**Service Information:** **New design without helix****Corteco No** **12011834B**

OE-Reference G151415

Make Case IH

Model 125, 700, 900, 1000, 1200

Figure 1: old version

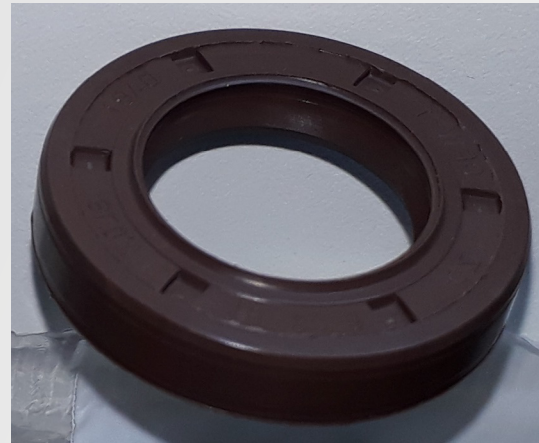
The design of the oil seal 12011834B has changed in shape in order to ensure a better performance. Compared to the previous version, the component no longer has any helix.

This variation does not affect the quality of the product nor its ability to retain the oil since the previous version was a bi-directional helix seal.
